**Post Submission Matters for
Environmental Impact Statement
for Andersons Clay Mine Extension
DA10.2018.36584.1**

Project Site	Andersons Clay Mine, ML1229 (Act 1973)
Report Title	Post Submission Matters for Andersons Clay Mine Extension

Table 1. Additional Information Requests and Responses

Figure 4.7 Maximum batter gradient (H:V) where the R-factor is 1,100, 1,400, 1,800 and 2,400 (adapted from Morse and Rosewell, 1993) (Appendix A)

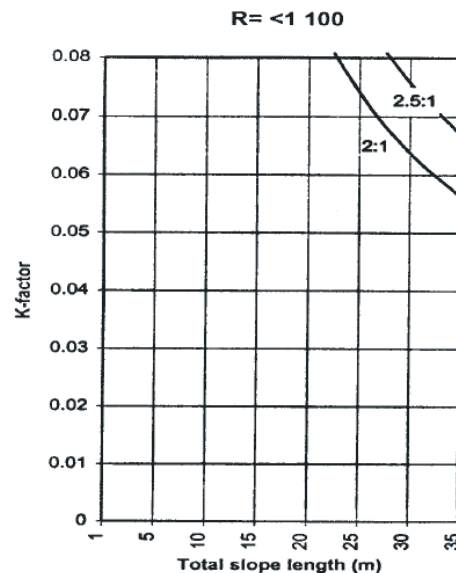
Item	Where located in the Rehabilitation Plan	Proposed Final land Use	Section 4- Post Mining Land Use Options, Section 6.5- Conceptual Final Landform and Figure 8 for the proposed Final Landform.	Rehabilitation Staging	Section 6.2- Mine Staging and Progressive Rehabilitation.	Targets	Section 5.1- Rehabilitation Objectives, Section 8- Performance Criteria.	Monitoring and Evaluation	Section 8- Performance Criteria and Section 11- Monitoring and Maintenance.	Adaptive Management Measures	Section 10- Intervention and Adaptive Management.	Diverse Understory Planting	Section 3.5- Vegetation Communities, Section 6.6- Revegetation and Section 9.5- Vegetation
Item	Where located in the Rehabilitation Plan														
Proposed Final land Use	Section 4- Post Mining Land Use Options, Section 6.5- Conceptual Final Landform and Figure 8 for the proposed Final Landform.														
Rehabilitation Staging	Section 6.2- Mine Staging and Progressive Rehabilitation.														
Targets	Section 5.1- Rehabilitation Objectives, Section 8- Performance Criteria.														
Monitoring and Evaluation	Section 8- Performance Criteria and Section 11- Monitoring and Maintenance.														
Adaptive Management Measures	Section 10- Intervention and Adaptive Management.														
Diverse Understory Planting	Section 3.5- Vegetation Communities, Section 6.6- Revegetation and Section 9.5- Vegetation														
Point vii	The proposed final landform slopes of 3:1 (horizontal to vertical) for the final landform are not recommended given the poor soil condition and the dispersive nature of the soil, which will prove to be very challenging, flatter slopes as per the original consent 5:1 (horizontal to vertical) would have far greater success in achieving the rehabilitation objectives for the site. The minimum slope that would be acceptable would be 4:1 (horizontal to vertical).

The Blue Book recommends slope lengths and gradient relationships base on the Soil Erodibility (k-factor) and Rainfall Erosivity (R-factor). BOM IFD data indicates the site has an R-factor of 1,010 and the k-factor has been assumed to be high i.e. 0.050. Using *Figure 4.7* from provided in the Blue Book, the maximum slope length recommended on a 3 horizontal to 1 Vertical slope before a cross drain is installed is greater than 35 metres as shown below.

The Blue Book recommends slopes generally be no greater than 80 metres before an earth bank or catch drain be installed. Catch drains are designed to convey surface water from the slope before it has reached sufficient velocity volume that erosion may occur (due to the transition from sheet flows to turbulent flows). In the Rehabilitation Plan *Section 8- Performance Criteria, Landform Establishment* it describes the slopes lengths permitted for the site in order to minimise erosion (see below) which are less than the Blue Book recommendations illustrated above.

These Performance Criteria have been derived from the Mine Operation Plan (MOP) approved by the DPIE. The final slopes of 3H:1V and catch drain intervals proposed are well within best practice according to the Blue Book and provide for a safe and stable final landform. Topsoil Quality As stated in the Rehabilitation Plan topsoil (onsite or imported) will be assessed prior to emplacement on the final slopes in order to determine if any ameliorants are required. Dispersive soils can be treated with gypsum to reduce the risk of dispersion and therefore erosion and this should not be a barrier to reuse on final slopes where the base material stability has been assessed as satisfactory at slopes of 3H:1V (see above). As stated in <i>Section 9.4.1</i> of the Rehabilitation Plan, other ameliorants may be added to promote vegetation growth as required after testing. C-Factors <i>Section 9.3- Soils and Erosion</i> addresses the management of soils on the site to minimise erosion and is discussed in terms of achieving C-factors (coverage factor) as a measure of soil stability and resistance to erosion impacts. The cover factor, C, is the ratio of soil loss from land under specified crop or mulch conditions to the corresponding loss from continuously tilled, bare soil. A C-factor of 1.0 corresponds to that of bare soil. Rehabilitation within the Plan and EIS is defined as final surfaces having achieved a C-Factor of less than 0.1 which is the equivalent of 60% groundcover for recently disturbed soils. The Desired C factor can be achieved via vegetation, mulch or suitable soil binders such as hydromulch as discussed in the plan. Regardless of how the desired C-Factor is achieved, it indicates that the site is resilient to erosion impacts. Vegetation Vegetation will be established in order to achieve the C-Factors described above. As discussed, there are several means to achieve the desired C-Factor immediately such as mulch and hydromulch. These can be used to stabilise the topsoil until such time as the native vegetation and grasses establish. Both mulch and hydromulch are suitable for use on slopes up to 3H: 1V. As can be seen from the photo below, there are a number of areas where the slopes are a 3H: 1V or steeper where native vegetation is established. The local species to be utilised in the rehabilitation is also well adapted to the soils in the area. Further, temporary rehabilitation established on the site on steeper slopes has been successful and shows no indication of erosion or lack of stability as shown below on the northern highwall where slopes are up to 2H: 1V.
